# Updated Technical Information

This information has been provided to you for the following reasons:

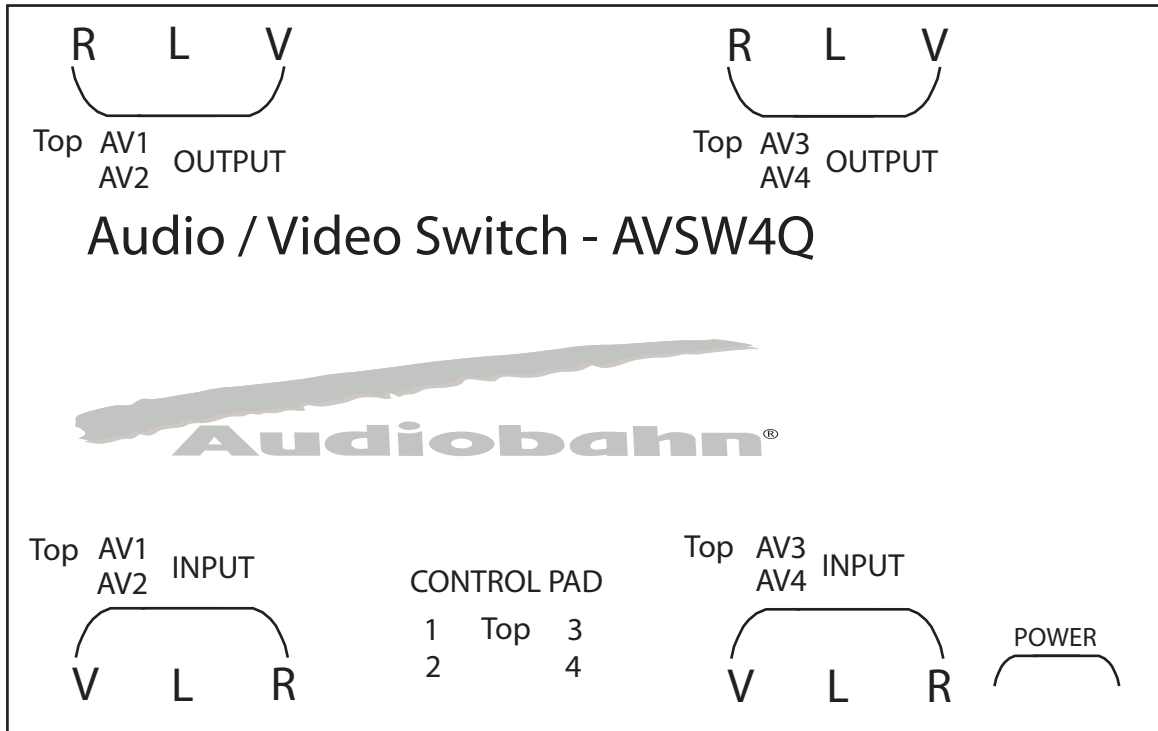
1. The AV outputs have been marked incorrectly on the wrong sides of the unit. AV1 & AV2 outputs should be on the left side. (same as the AV1 & AV2 inputs)
2. The AV3 & AV4 outputs should be on the right side. (same as the AV3 & AV4 inputs)

## Button Layout

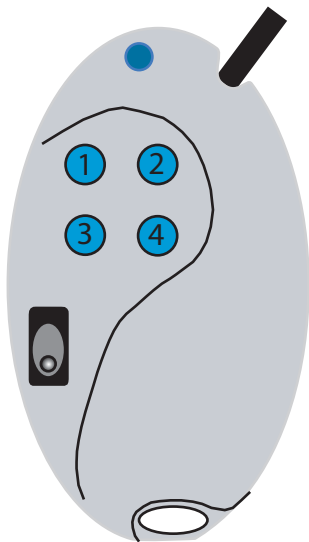
1. The buttons on the original remote are not labeled and differ from the new remote.
2. Look very carefully as buttons are marked on the diagram on both old and new remote.
